**Item 5.**

**Development Application: 207-229 Young Street, 881-885 and 887-893 Bourke Street, Waterloo - D/2020/45**

**File No.:** D/2020/45

Figure 59: Excerpt from the Tree Location Plan (Source: AIA report, Birds Tree Consultancy, Rev. A, dated 14 April 2021)

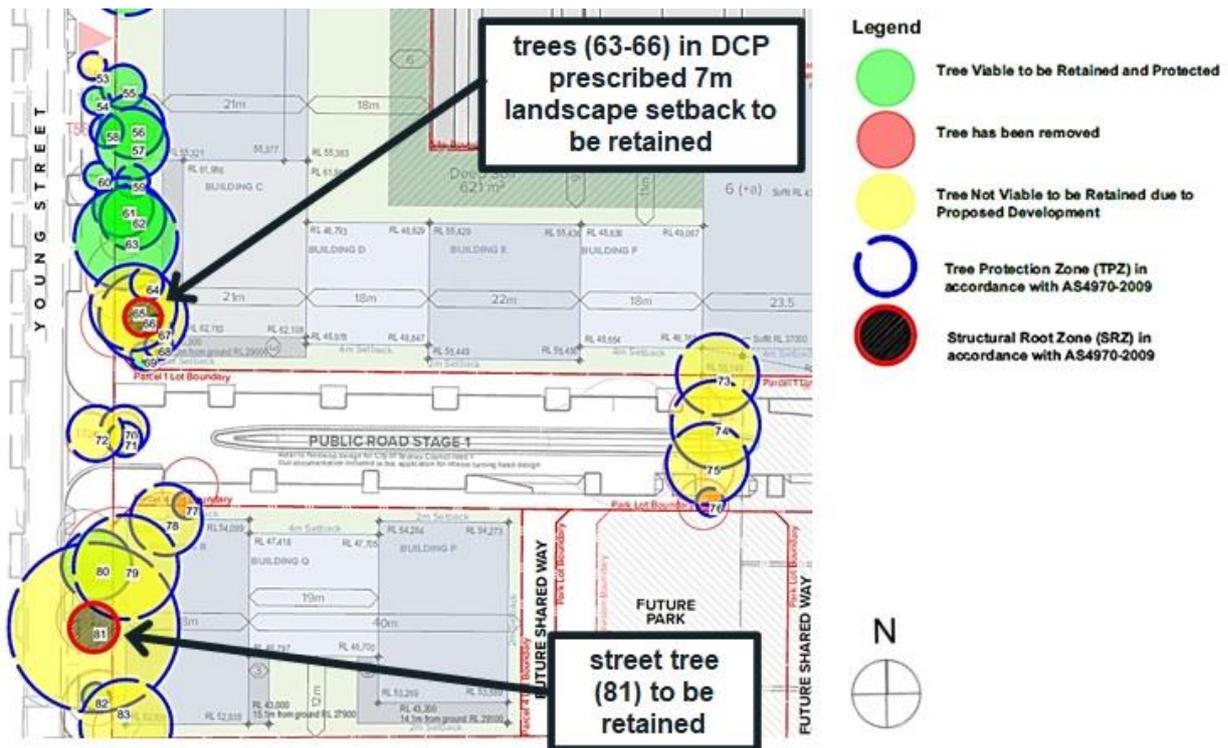
- (f) trees numbered 79 and 83 are large mature *Corymbia citriodora* (Lemon-scented gum) trees located within the site. While these trees are in good health their retention would severely inhibit the development potential of the south-western development parcel (Parcel 4, Lot 2). A condition is recommended for their removal and

- (g) tree 81 is a large, mature and healthy *Melaleuca quinquenervia* (Paperbark) street tree (in Young Street). The subject DA proposes to remove tree 81 to make way for the proposed vehicle access point for the new building to be contained within (Parcel 4) Lot 2. Were the proposed vehicle access location to be approved, not only would the city lose a tree, but it would lose a tree pit/space and any subsequent opportunity for future street tree plantings in this location. Removal of this tree is not supported, and a condition is recommended for its retention. As discussed in the Vehicle Access Locations section of this report below, conditions are recommended for investigations into whether the vehicle access location to (Parcel 4) Lot 2 can be moved further south so tree 81 can be retained.

Figure 61: Proposed location of substation within proposed new (Parcel 1) Lot 1

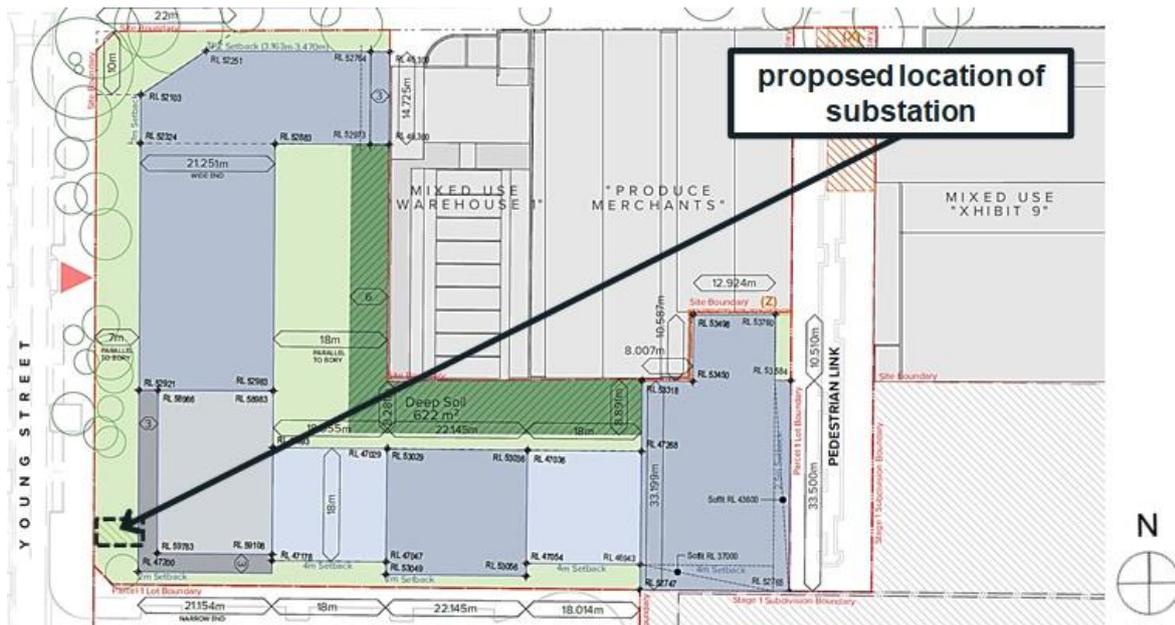
- (a) as shown in Figure 61 below, it is proposed that the large existing substation currently located near the street frontage of and within the property at 207-229 Young Street is relocated further north to a position within the 7m landscape setback to Young Street;

- (b) this proposed variation would undermine the achievement of the objectives of the Danks Street South urban strategy to use landscaping to manage stormwater quality and to create a strong and consistent landscape character throughout the precinct. Furthermore, it would necessitate the removal of several trees (two large healthy Paperbark street trees and two large healthy Lemon-scented gum trees within the site);
- (c) the proposed new location of the substation is not supported. Conditions are recommended for relevant design modifications and for any substation to be provided as a chamber substation that is integrated into the architecture of any building contained within the approved concept envelope in (Parcel 1) Lot 1.

Figure 62: Plan and section diagrams of proposed upper level envelope encroachment into TSL setback

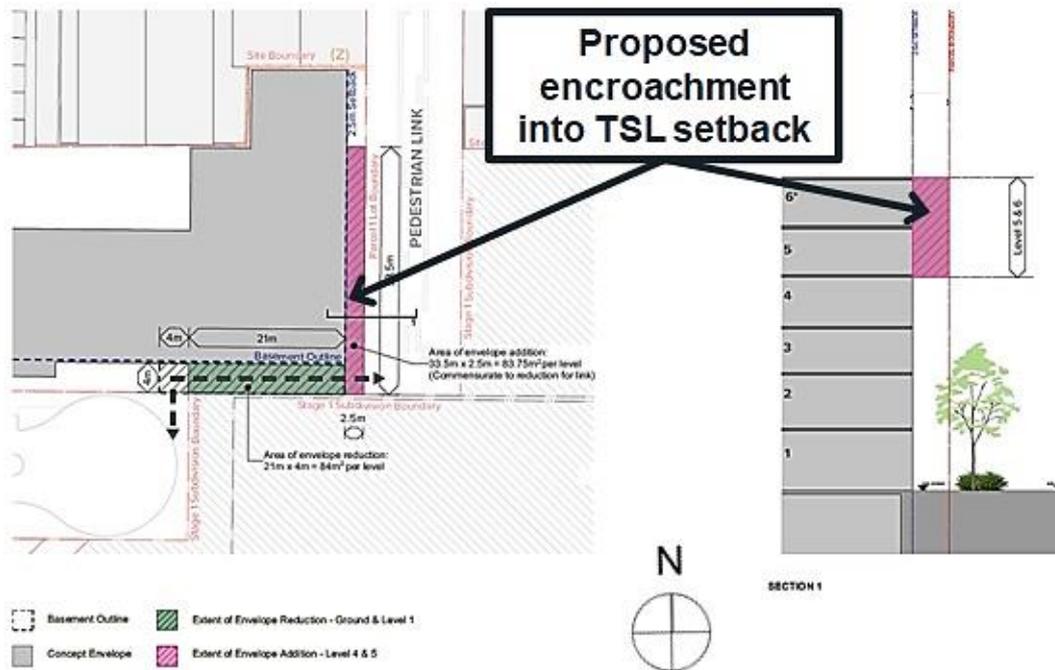
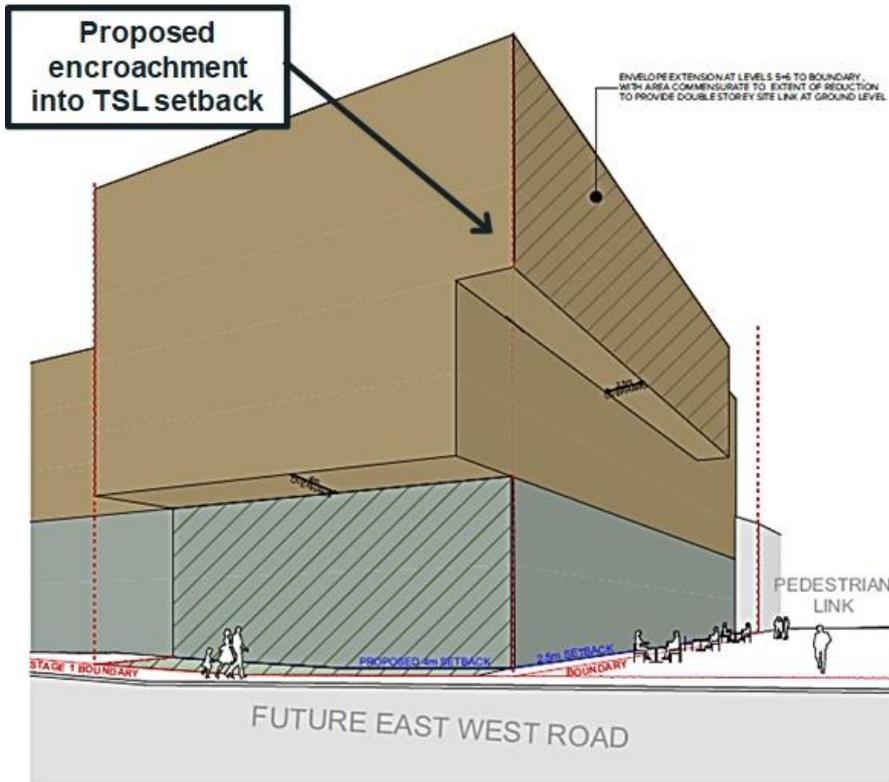
- (f) notwithstanding this non-compliance at upper levels, the eastern building alignment at the lower levels will comply with the DCP prescribed 2.5m setback to the TSL. This will provide opportunities for outdoor seating and activation of the ground level interface of the building with the TSL. Subject to conditions to set back the upper level 'pop-out' from the envelope's southern elevation (refer to Figure 64 below), the building contained within (Parcel 1) Lot 1 will provide a suitable gateway to the TSL when viewed from the south. This is consistent with the desired urban design outcome envisaged under the DCP setback controls.

- (g) relevant conditions are also recommended for design requirements to be included in any competitive design brief for the building contained within (Parcel 2) Lot 104. These conditions require:
  - (i) competitors to consider a similar distribution of bulk or a 'pop-out element' on the opposite side of the TSL to achieve some degree of volumetric symmetry to opposing buildings fronting the TSL (while acknowledging that the two buildings fronting the through site link will be of different heights) and
  - (ii) that the visual and acoustic privacy objectives 3F and 4H of the ADG are to be addressed notwithstanding potential non-compliances with the ADG's separation requirements arising from the proposed setback encroachment and design requirements recommended at sub-paragraph (i) above.

Figure 65: Comparison of DCP prescribed setbacks and proposed nil-setback to southern boundary of (Parcel 3) Lot 103 and the adjacent City West Housing site

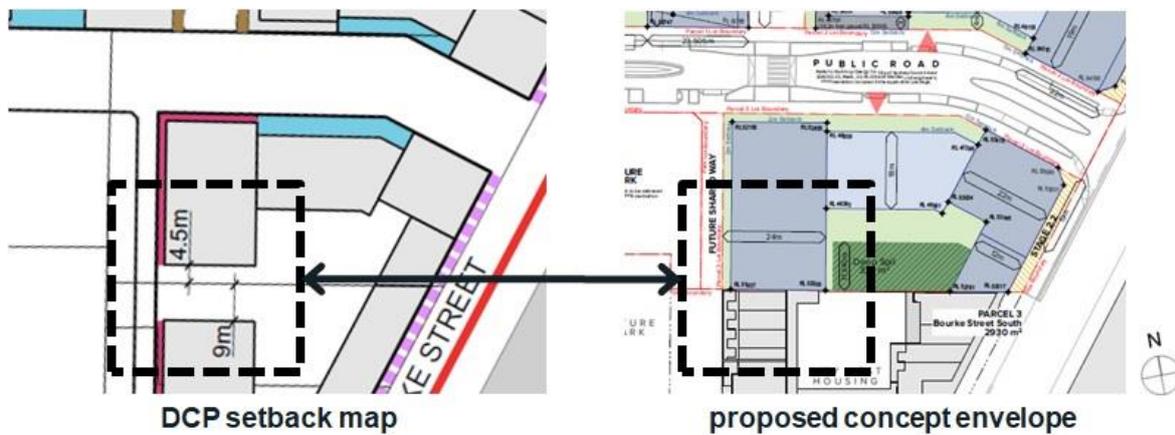
- (i) were the proposed concept envelope to be setback by 4.5m from its southern boundary with the City West Housing site, then it would result in a narrow, unsafe and un-useable strip of land with reduced opportunities for activation of the western elevation

- (ii) the proposed concept envelope with its nil-setback from the southern boundary provides for an improved urban design outcome which allows for a continuous active frontage to the public open space. Furthermore, the applicant submits that a future detailed design DA for the site could provide a double height building lobby to provide a visual and physical connection through to the internal courtyard instead.

Figure 68: Swept path diagram demonstrating large vehicles turning into site mount central median

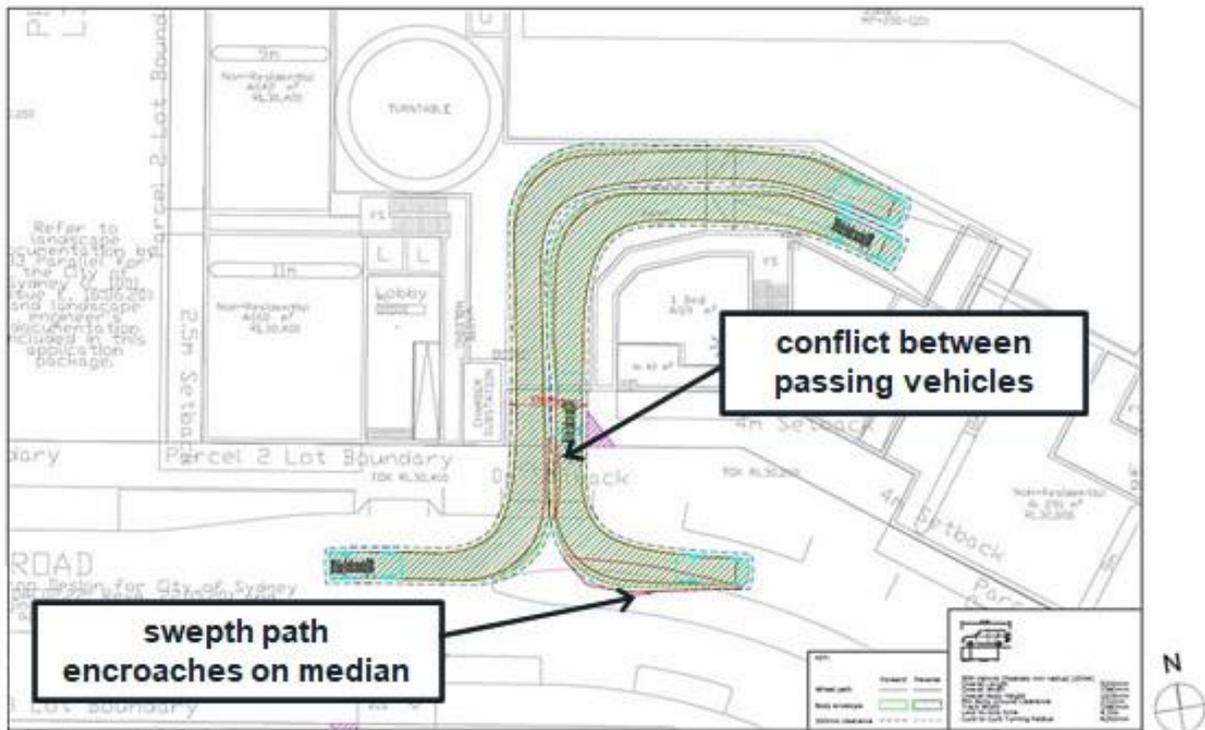
147. The proposed locations for vehicle access to the new north-eastern and south-eastern (Parcels 2 and 3) Lots 104 and 103, from the new east-west street are supported in-principle. However, as shown in Figure 68 below, the swept path analyses submitted as part of the subject DA demonstrate that the indicative driveway designs do not provide suitable access for large vehicles entering the site without mounting centrally located medians that form part of the city's Public Domain Concept Design for the new east-west street. The swept paths also demonstrate potential collisions of large vehicles entering/exiting the proposed new driveways.

148. To address these concerns, conditions are recommended for:

Figure 77: Views from the sun diagram at 1pm to the affected Tiara building. Living room windows of the 8 west-facing apartments to which 2 hours of sunlight is to be retained are shaded in dark green. Shaded pink areas are the likely requisite bulk reductions at the time shown.

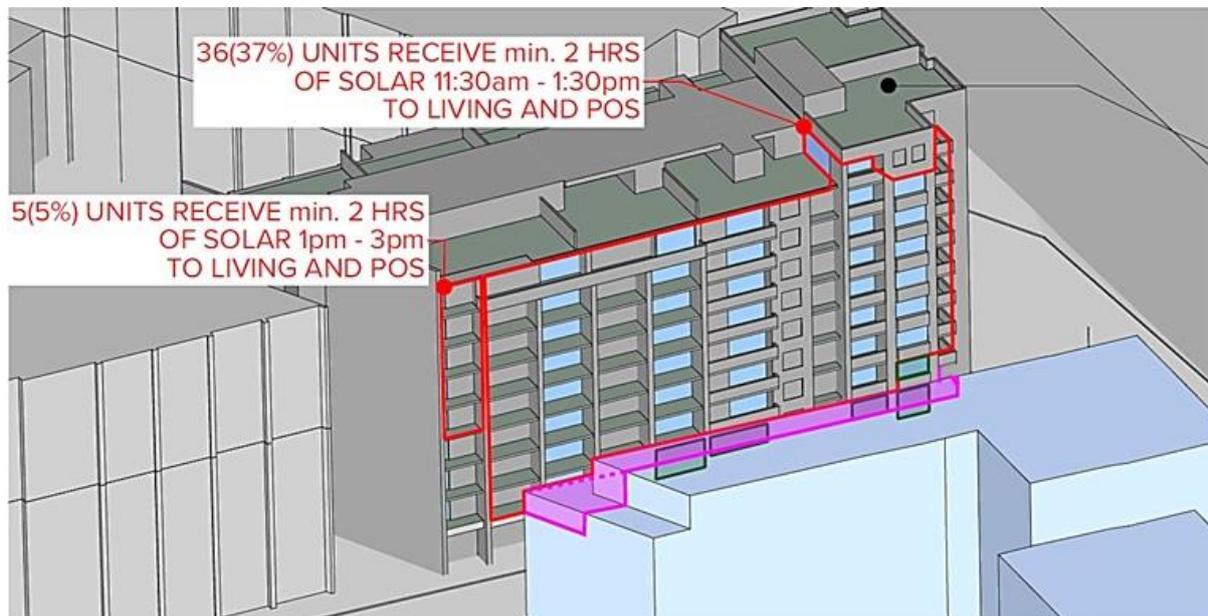
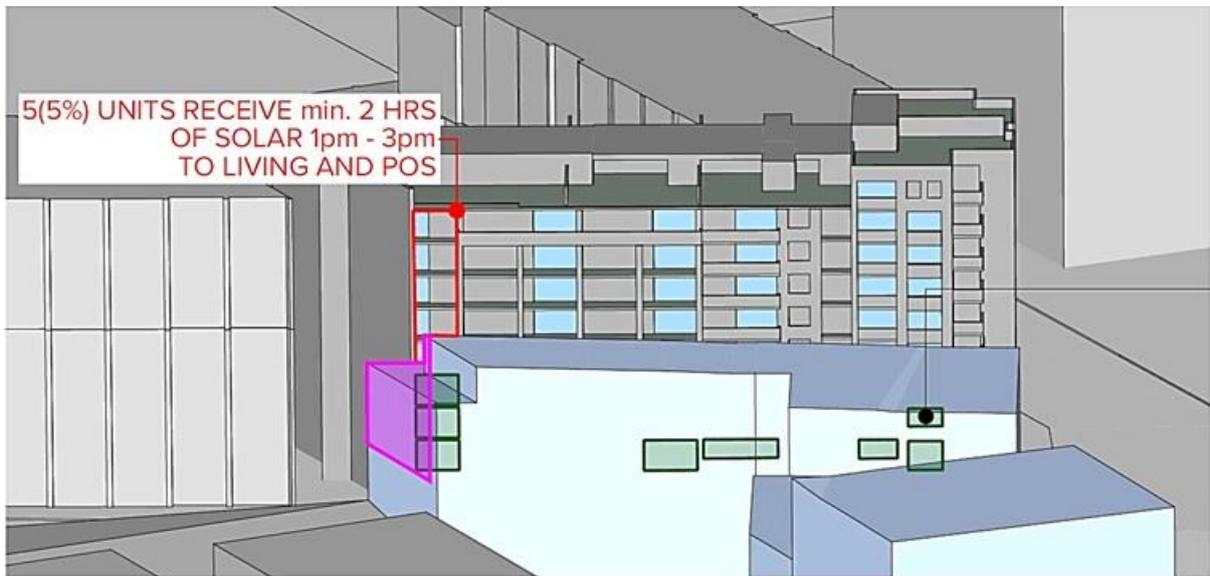
180. The proposed concept envelopes unamended will reduce solar access to the affected building within the Tiara development, with 43% of apartments (42 apartments) receiving 2 hours of sunlight to living rooms and private open spaces and 42% of apartments (41 apartments) receiving no direct sunlight.

181. The reduction in the number of apartments that receive a minimum of 2 hours' sunlight to living rooms and private open spaces from a non-compliant 52% (50 apartments) down to 43% (42 apartments) of apartments is not in-keeping with the design guidance to ADG objective 3B-2 or the design criteria to ADG objective 4A-1.

182. To achieve consistency with the ADG objectives, the detailed design of the building within the proposed new (Parcel 2) Lot 104 must not result in a further reduction in the number of apartments in the affected Tiara building that receive the minimum 2 hours of sunlight to living rooms and private open spaces. The private open space and living room windows to the 50 apartments, to which solar access must be retained, are highlighted in pink in Figures 77 to 81 below.

183. Conditions are recommended for the proposed envelope to be amended to retain minimum solar access to the apartments within the affected Tiara building, in accordance with the design guidance to ADG objective 3B-2 and the design criteria to ADG objective 4A-1, as described in the paragraph above. Increased setbacks to building mass within the proposed new (Parcel 2) Lot 104 that are the likely design outcome from this condition are marked in a pink line in Figures 77 to 81 below. Note that the setbacks marked in a pink line are indicative only. The setbacks incorporated into detailed designs to address the recommended condition will be established through modelling of the cumulative reductions in massing over the time periods shown in Figures 77 to 81.

Figure 82: Diagram of further setting back of any massing enabled by the 10% design excellence height uplift to reduce overshadowing impacts to apartments in the City West Housing building

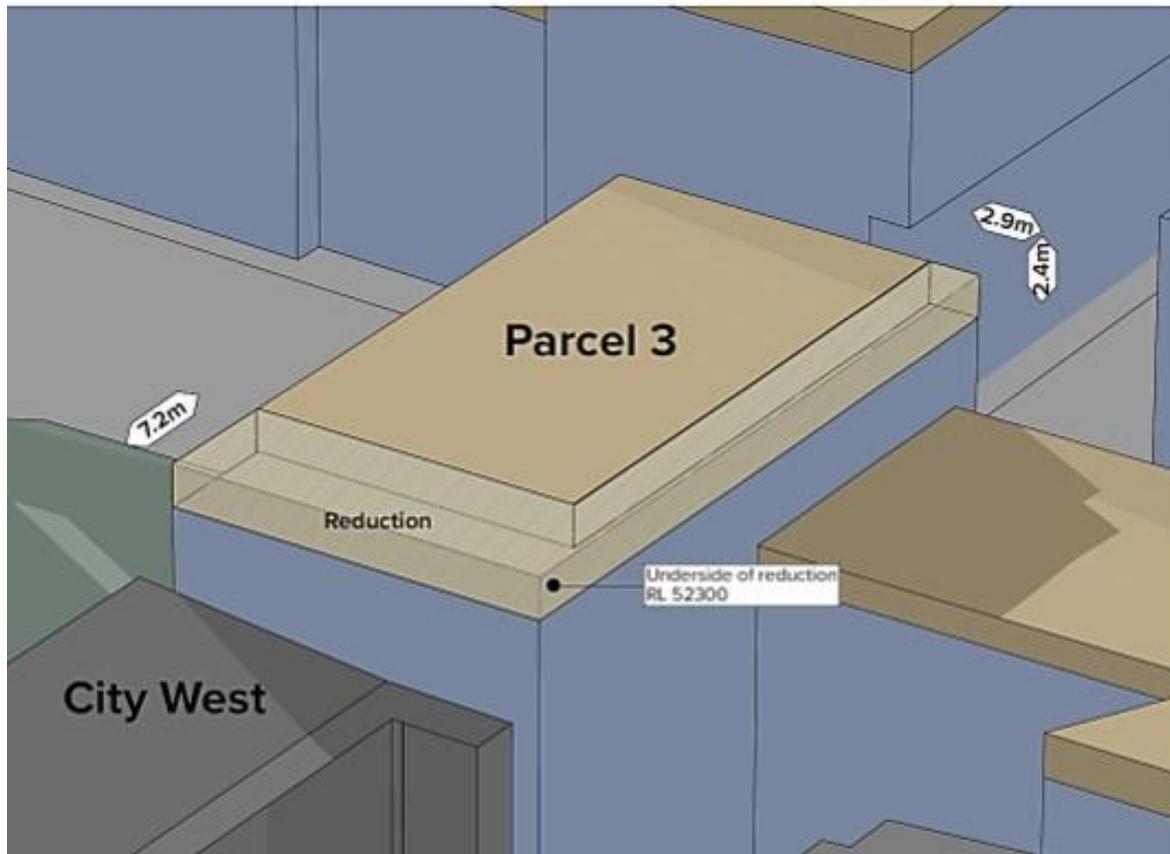
188. The proposed concept envelopes, shown in blue in Figure 82 comply with the base height of buildings control at clause 4.3 of the LEP. These envelopes are separated from the building approved to be constructed on the City West Housing site by up to 19m and are generally consistent with the built form and massing requirements of the DCP.

192. This modelling demonstrates that subject to further setting back of any massing enabled by the 10% design excellence height uplift (as shown in Figure 82 below), there is no further reduction in solar access to apartments contained within the City West Housing site building beyond that which would be caused by concept envelopes that do not incorporate any additional height.
